State of New Mexico
Energy, Minerals and Natural Resources
OIL CONSERVATION DIVISION
1220 South St. Francis Dr.
Santa Fe, NM 87505

SUNDRY NOTICES AND REPORTS ON WELLS (DO NOT USE THIS FORM FOR APPLICATIONS TO DRILL OR TO DEEPEN OR PLUG BACK TO A DIFFERENT RESERVOIR. USE "APPLICATION FOR PERMIT" (FORM C-101) FOR SUCH PROPOSALS.)		WELL API NO. 30-025-34323
1. Type of Well: Oil Well ☒ Gas Well ☐ Other Water Injection ☐		5. Indicate Type of Lease STATE ☒ FEE ☐
2. Name of Operator Chevron U.S.A. INC.		6. State Oil & Gas Lease No.
3. Address of Operator 15 Smith Road Midland, TX 79705		7. Lease Name or Unit Agreement Name MONUMENT "23" STATE
4. Well Location Unit Letter <u>M</u> : <u>753</u> feet from the <u>SOUTH</u> line and <u>637</u> feet from the <u>WEST</u> line Section <u>23</u> Township <u>19-S</u> Range <u>36-E</u> NMPM County <u>Lea</u>		8. Well Number: <u>19</u>
11. Elevation (Show whether DR, RKB, RT, GR, etc.)		9. OGRID Number: 4323
		10. Pool name or Wildcat MONUMENT; ABO

WELL DATA SHEET

PROPOSED

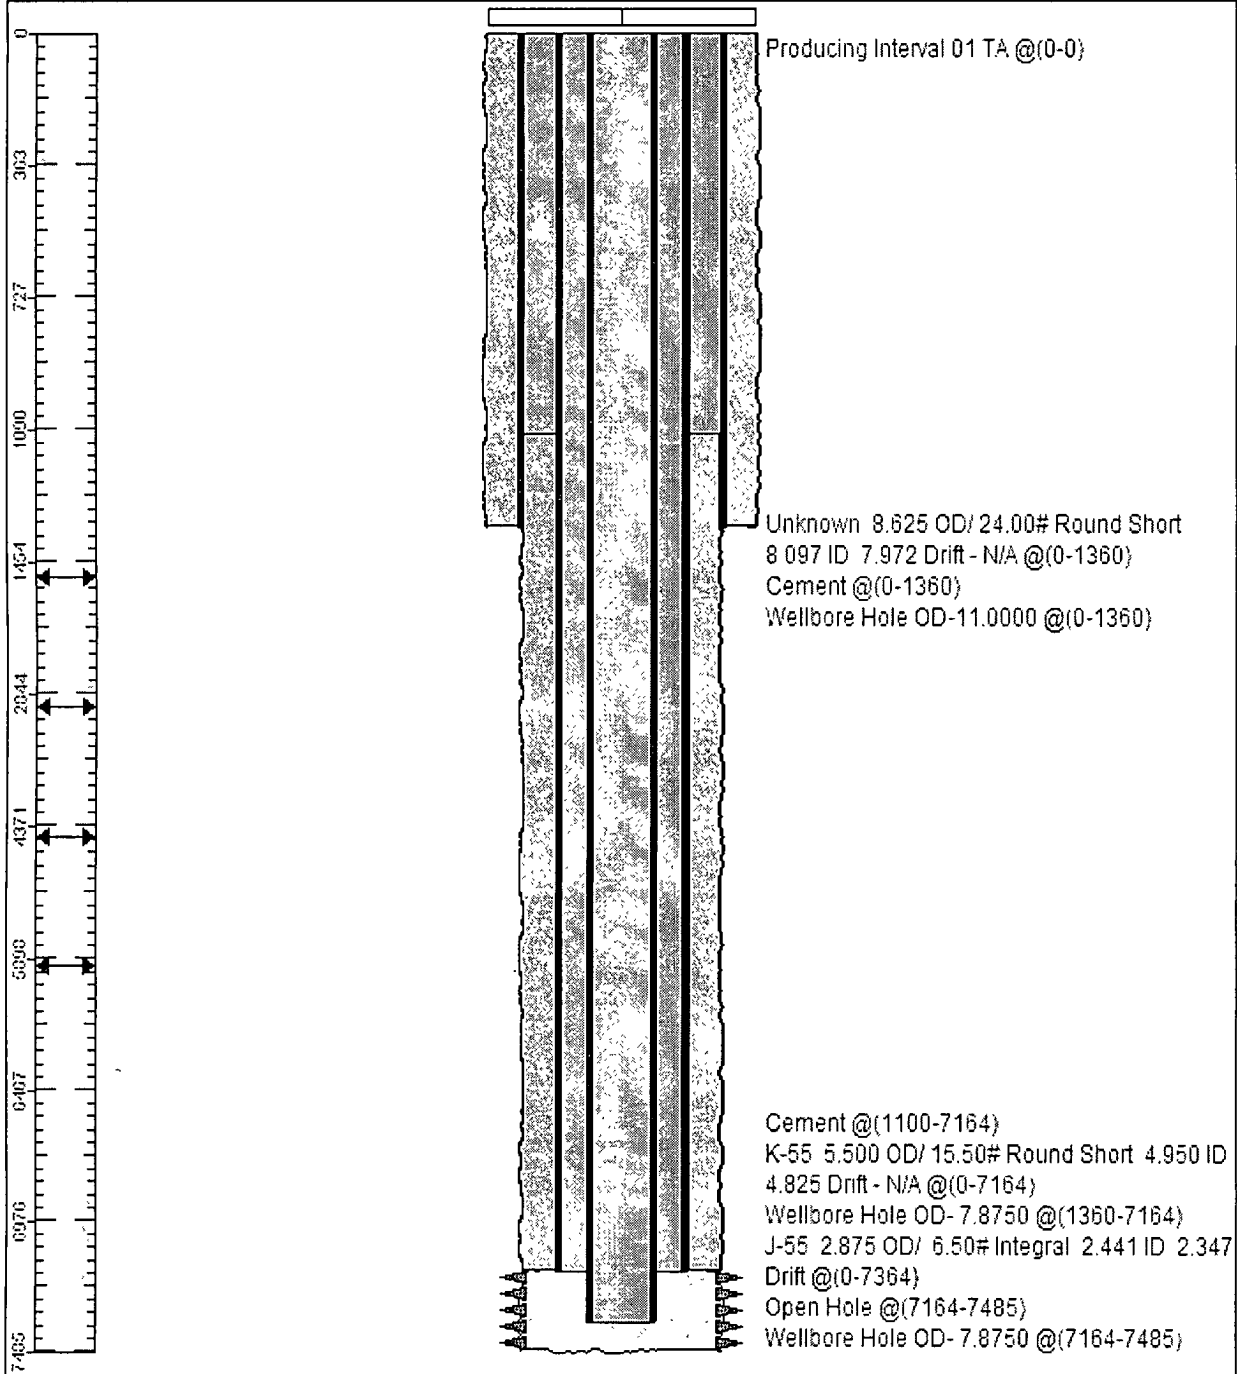
1. MIRUWSU. NDWH. NUBOPE.
2. Pressure Test casing to 500 psi and record/report findings.
3. 3B RIH, Tag CIBP @ 7130' w/30 sx of C cement. *→ CIRC WELL w/ MEF*
4. Set plug w/25 sx of C cement @ 2675' CTOC. WOC & TAG
5. Set plug w/30 sx of C cement @ 1473' CTOC. WOC & TAG
6. Perf & Circulate ~~100 sx~~ of C cement @ 100' - Surface.
7. Cut off wellhead and anchors 3' below grade. Weld on dry hole marker. Clean location.

Oil Conservation Division - Hobbs office Must be Notified
24 hours prior to the beginning of Plugging Operations begin
